UNITED STATES
NUCLEAR REGULATORY COMMISSION
WASHINGTON, D.C. 20555-0001

SUBJECT: COOPER NUCLEAR STATION – SAFETY EVALUATION REGARDING
IMPLEMENTATION OF MITIGATING STRATEGIES AND RELIABLE SPENT
FUEL POOL INSTRUMENTATION RELATED TO ORDERS EA-12-049 AND
EA-12-051 (CAC NOS. MF0971 AND MF0972)

Docket No.: 50-298

Figure 1 – Cooper Nuclear Station SFP Levels of Monitoring

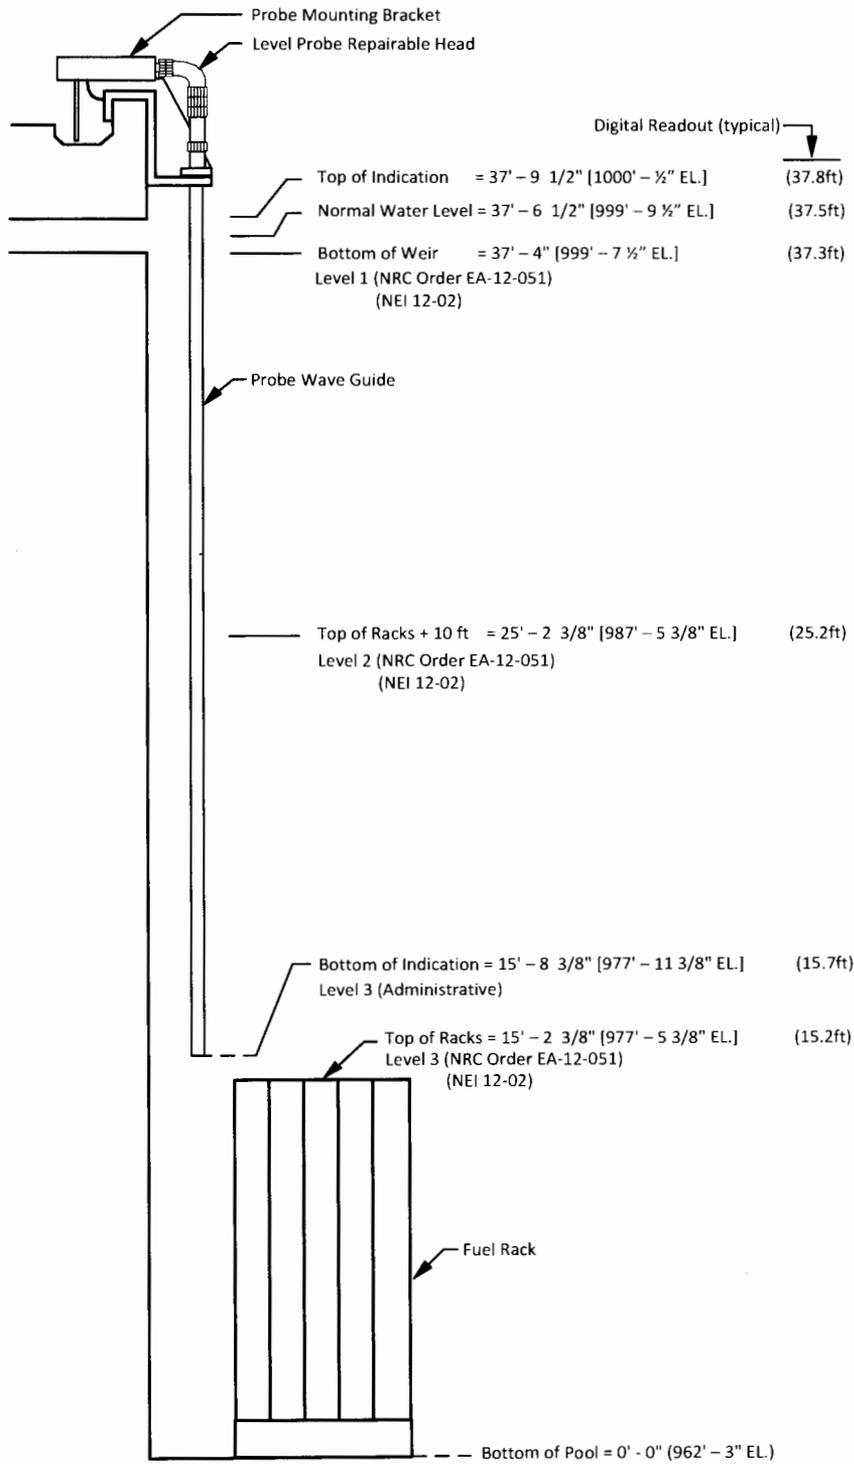
The NRC staff's assessment of the licensee's selection of the SFP levels of monitoring is as follows.

In its letter dated August 22, 2016 (ADAMS Accession No. ML16245A290), the licensee provided a sketch (Figure 1 - Cooper Nuclear Station SFP Levels of Monitoring) depicting the SFP level instrument's measuring range from 1000 ft. ½ in. to 977 ft. 11 3/8 in. plant elevations. The NRC staff noted that the instrument's measuring range (1000 ft. ½ in. elevation – 977 ft. 11 3/8 in. elevation) covers Levels 1 and 2 but does not cover Level 3 (977 ft. 5-3/8 in. elevation). In response to the staff's concern, in an email dated March 1, 2017 (ADAMS Accession No. ML17075A105), the licensee noted that Administrative Level 3 (977 ft. 11-3/8 in. elevation) is used in CNS's operation and calibration procedures. According to Procedure EOP 5A, "Secondary Containment Control," Revision 18, if the SFP water level drops 4 in. below the normal water level, operators will take action to restore and maintain SFP water level between 25 ft. 3 in. (987 ft. 6 in. elevation) and 37 ft. 9 in. (1000 ft. 0 in. elevation). If the water level continues to drop, EOP 5A directs operators to take actions to initiate SFP spray before the water level drops to 15 ft. 8.4 in. (Level 3 administrative - 977 ft. 11-3/8 in. elevation). This
